## Development Review Division

**TO:** Madeleine Reinke, Kimley-Horn and Associates, Inc.  
**FROM:** Cynthia Thye, Planner 1  
**DATE:** December 31, 2025  
**SUBJECT:** SP25-119: Lincoln Professional Park L2 - 7 Brews Coffee – Site Plan Review Comments 02

EXTERIOR ELEVATION MATERIALS SUMMARY		
WEST ELEVATION - 269.01SF TOTAL MAIN LEVEL FACADE AREA BETWEEN 2'-8" AND 8'-0" (100%)		
MATERIAL	MAX % / SF	PROPOSED % / SF
GLASS	MIN 40 % / 104.05F	PROPOSED 53.32% / 138.64SF
BRICK	MIN 60 % / 156.05F	PROPOSED 46.80% / 121.37SF

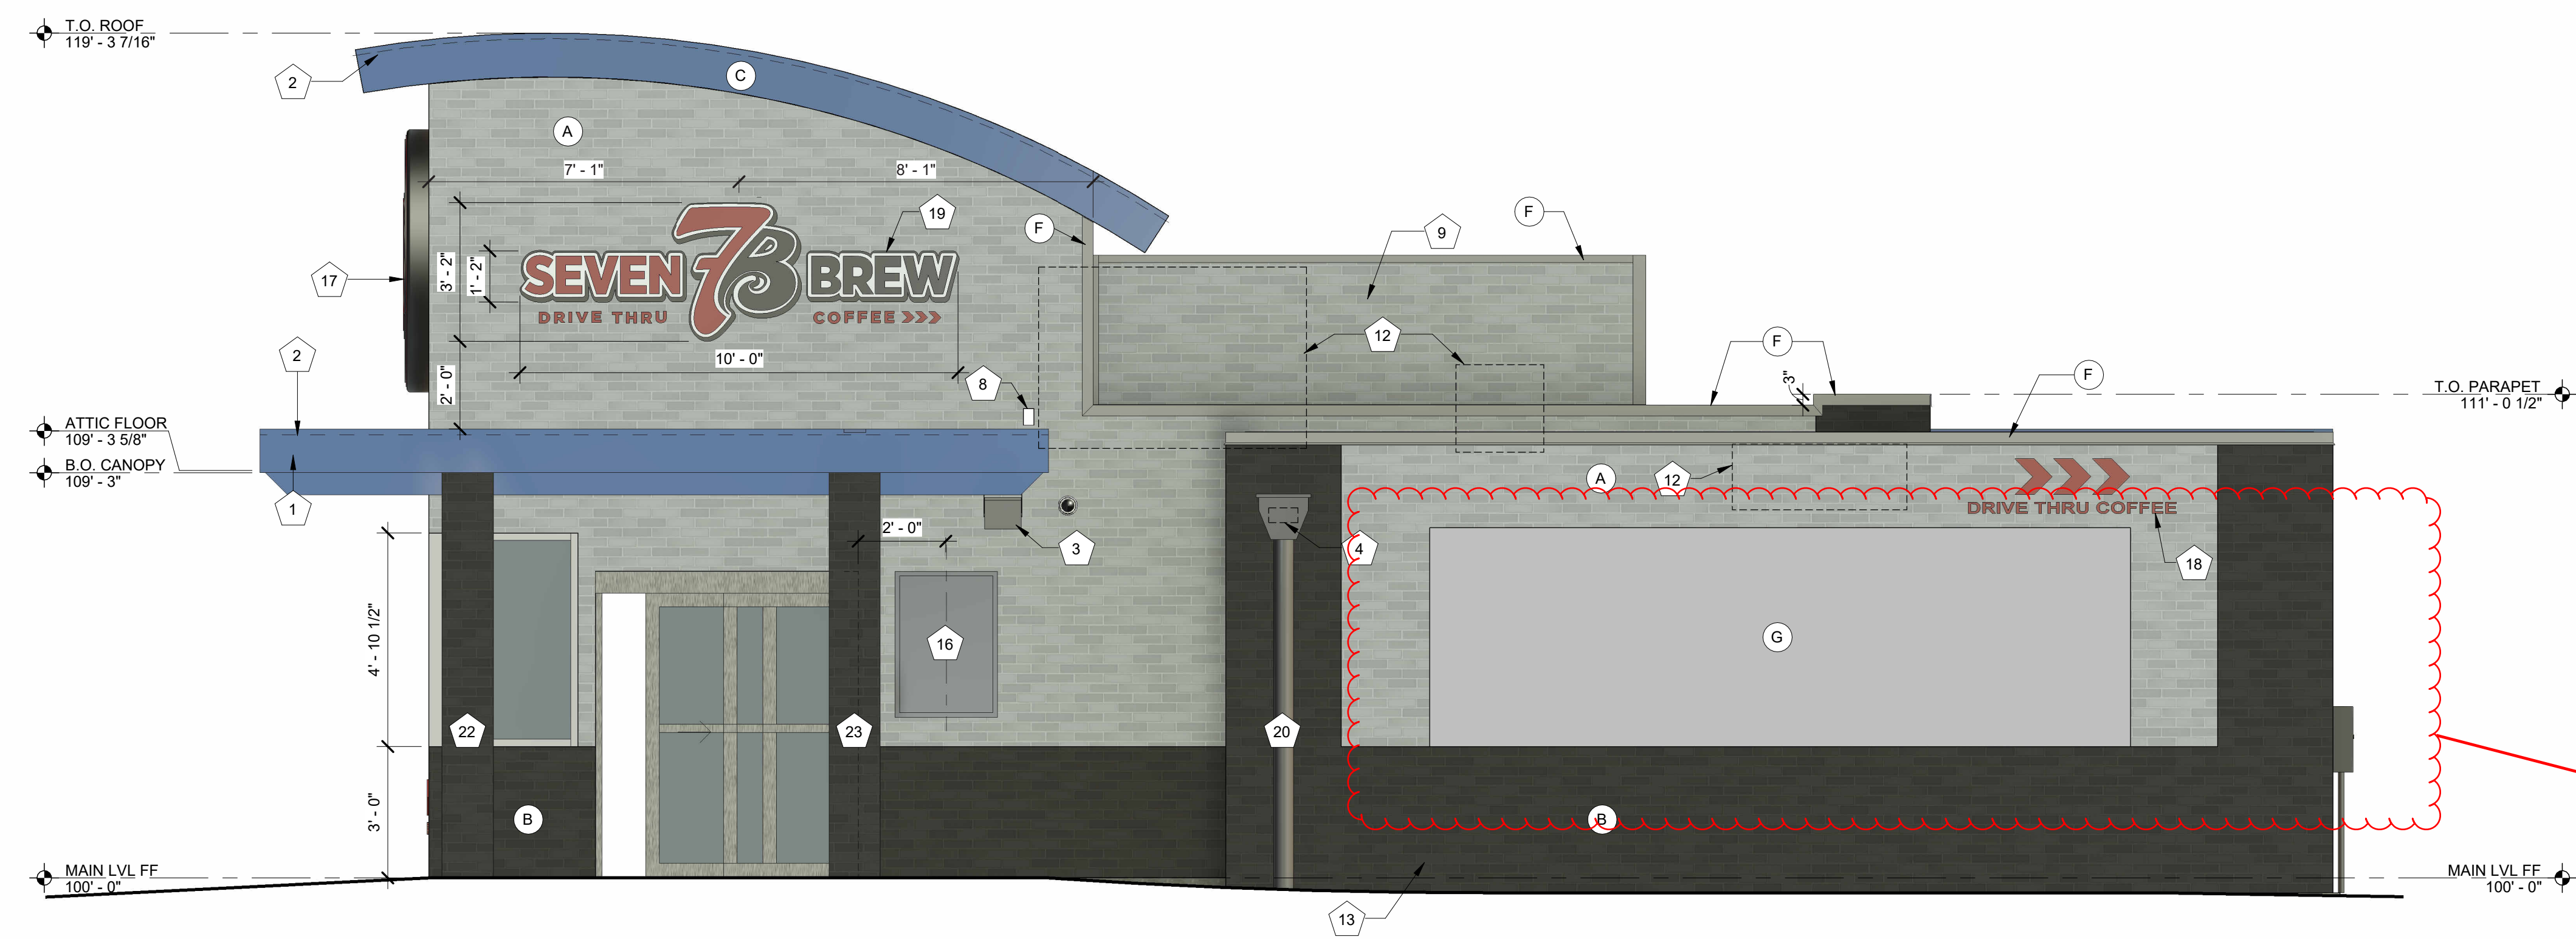
Provide an image of the proposed mural. It cannot be "logo art" of Seven Brew nor lettering, nor coffee image.

This image has been provided as a separate exhibit for the city's review.

### TRASH ENCLOSURE KEYNOTES

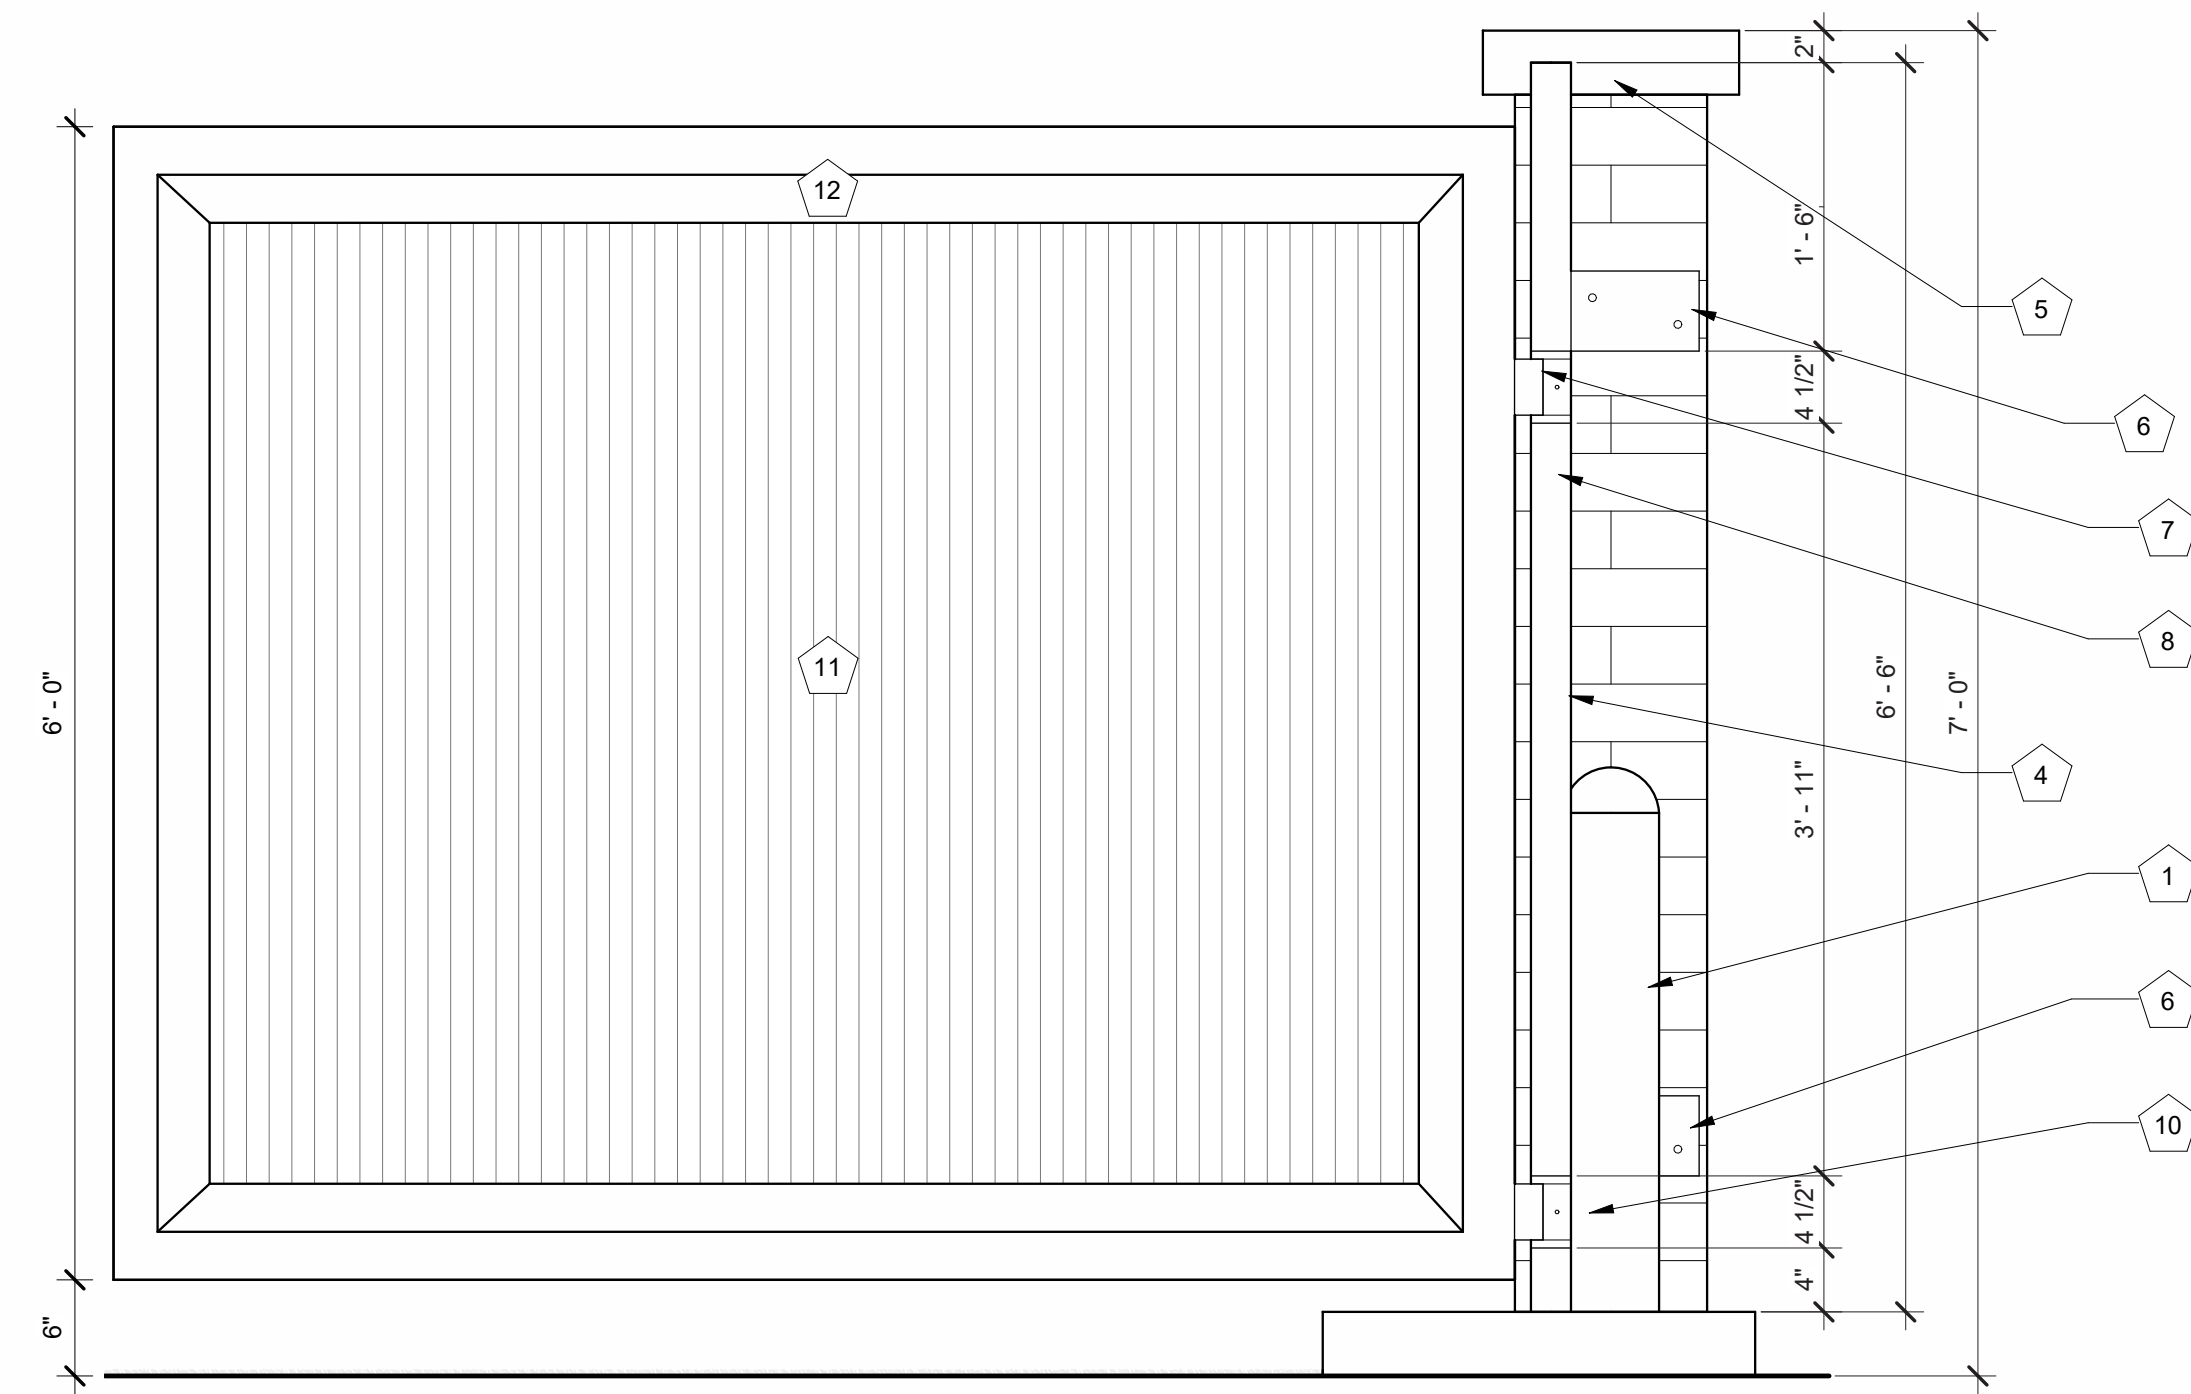
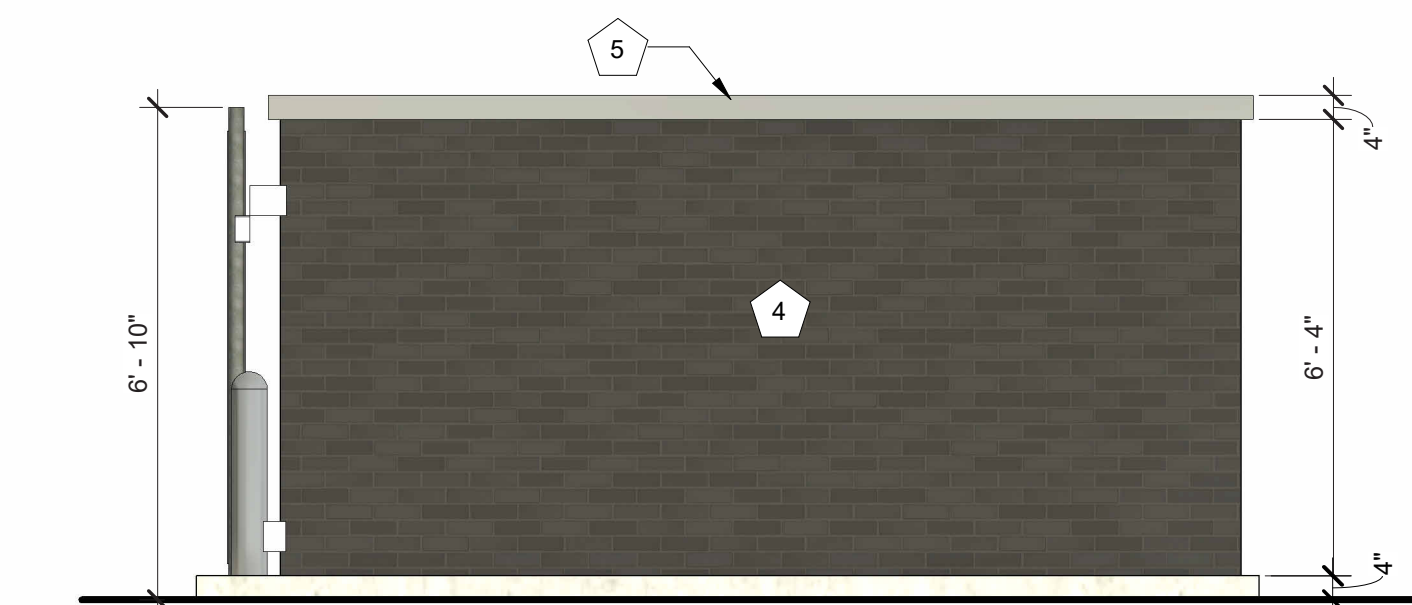
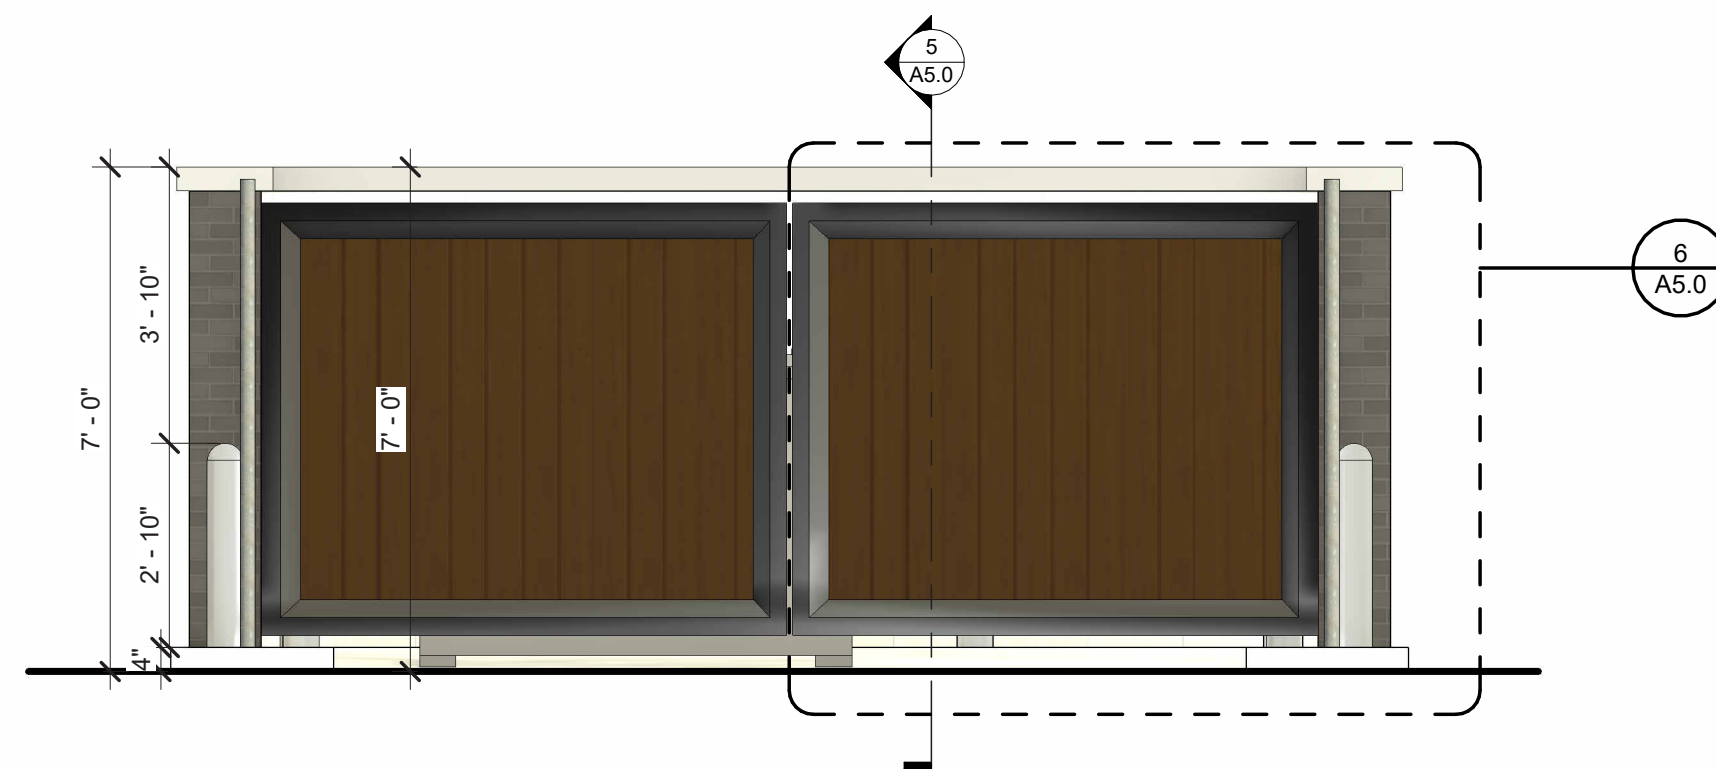
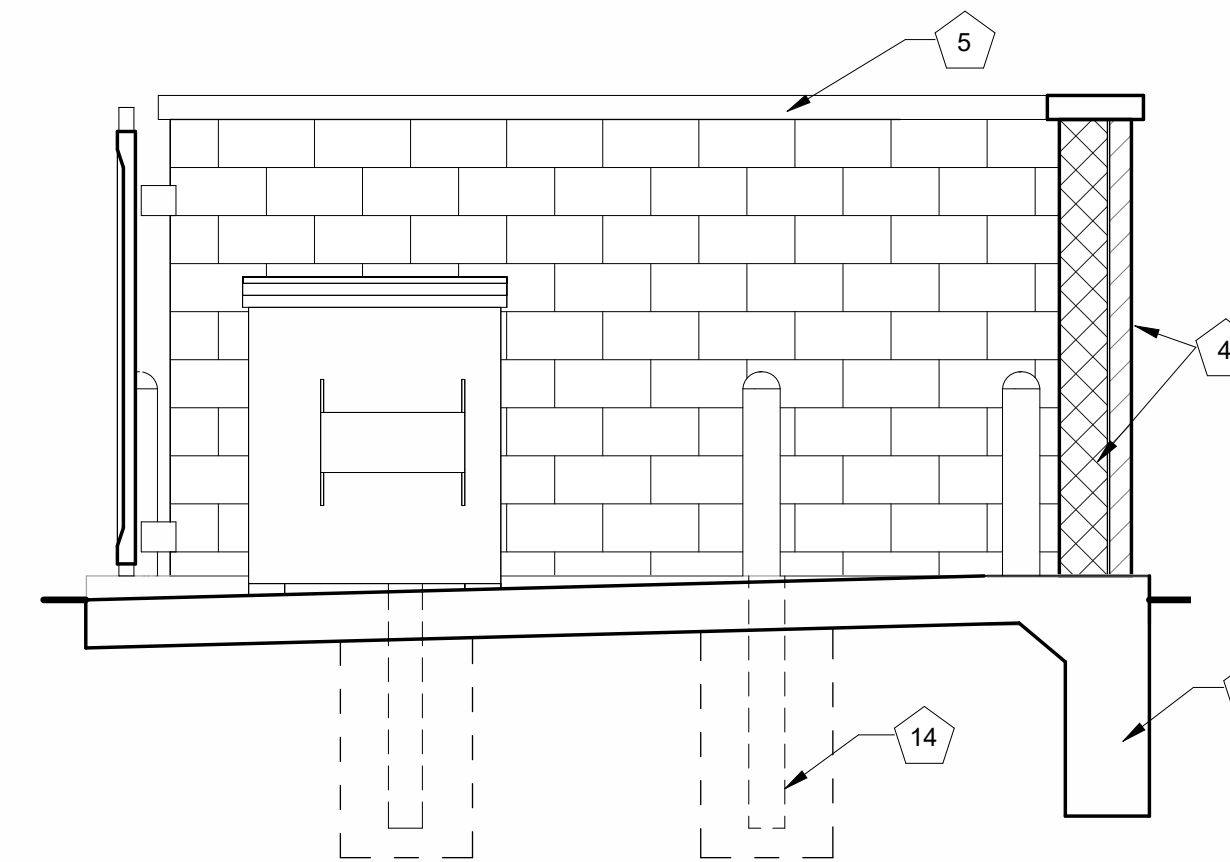
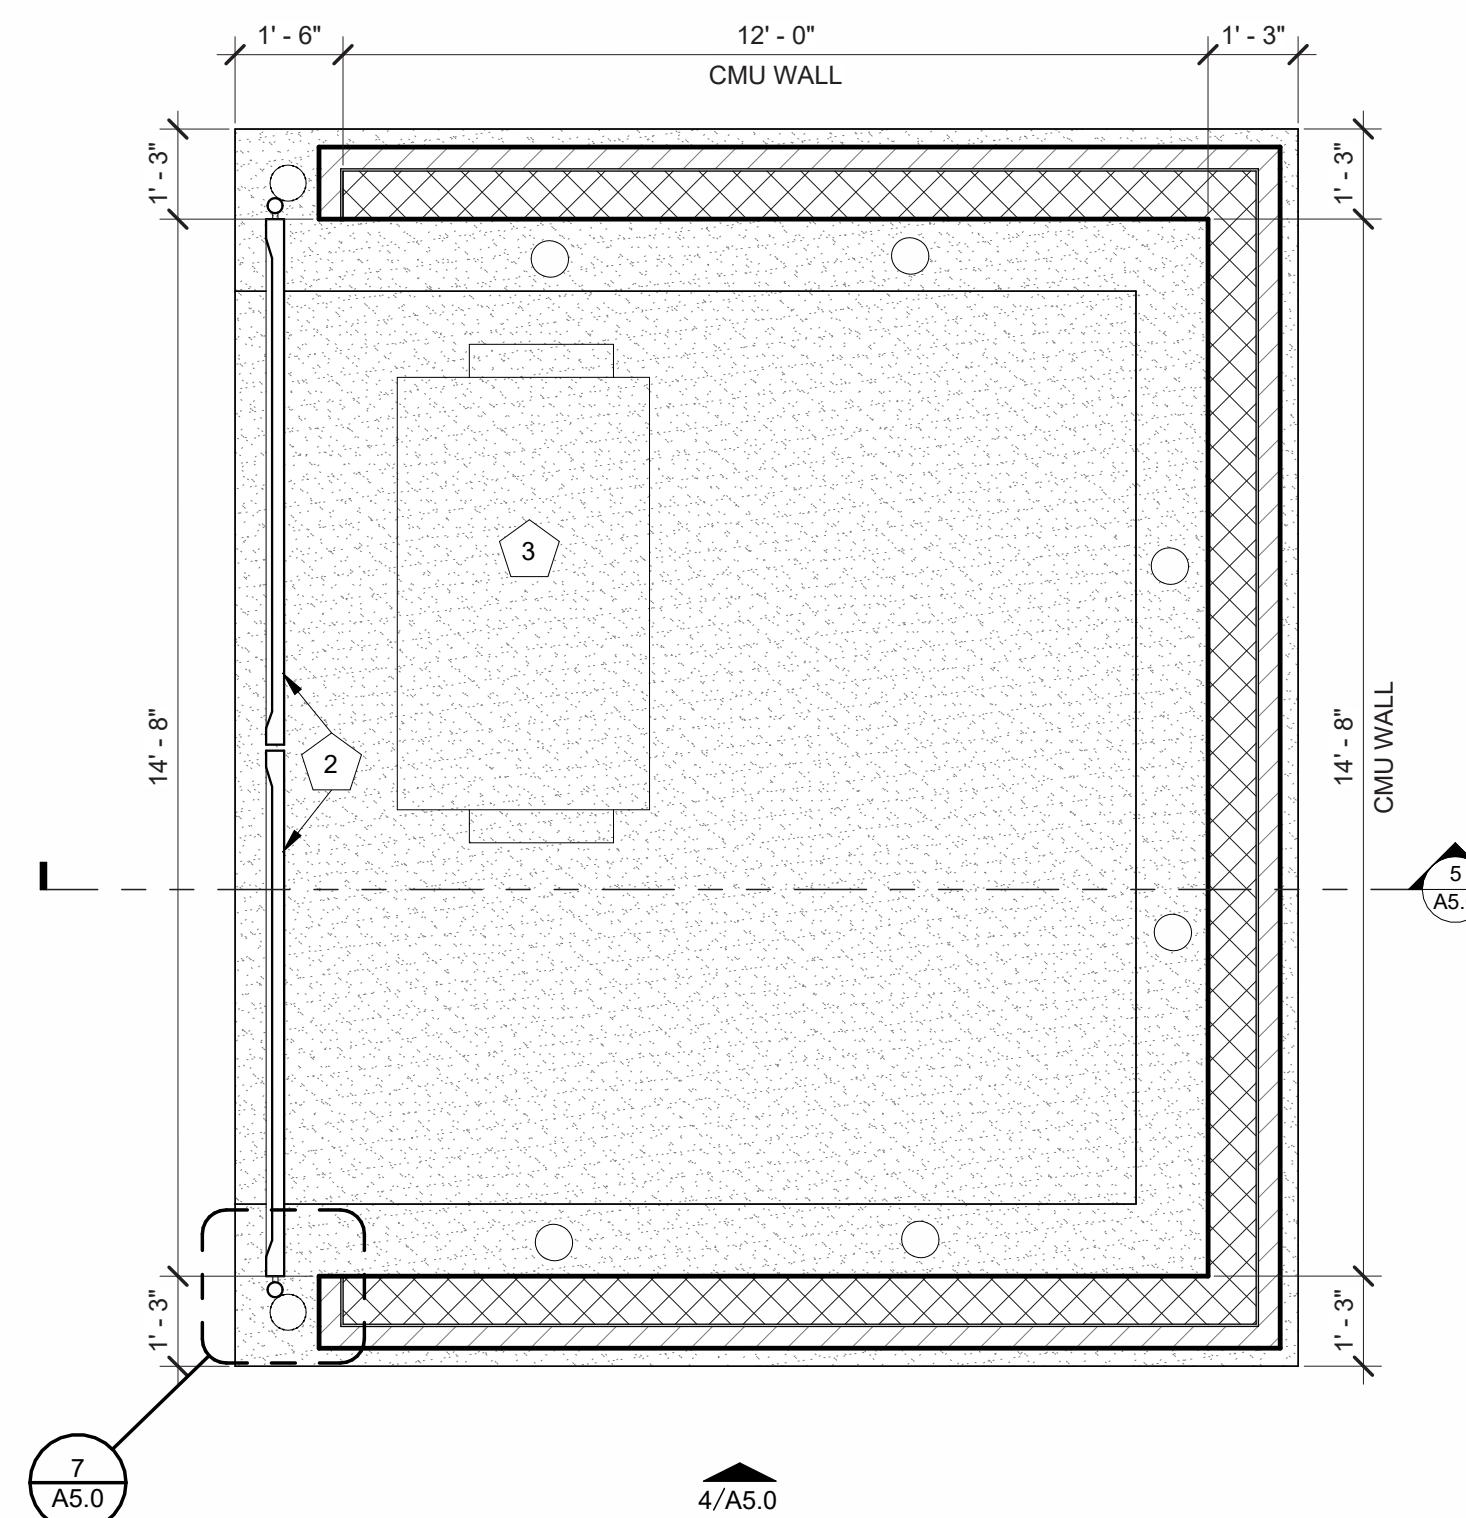
**14. Revise trash enclosure doors to be steel painted and color to match main building. Per LDO 13.08.130.**

Revised, see sheet A5.0.
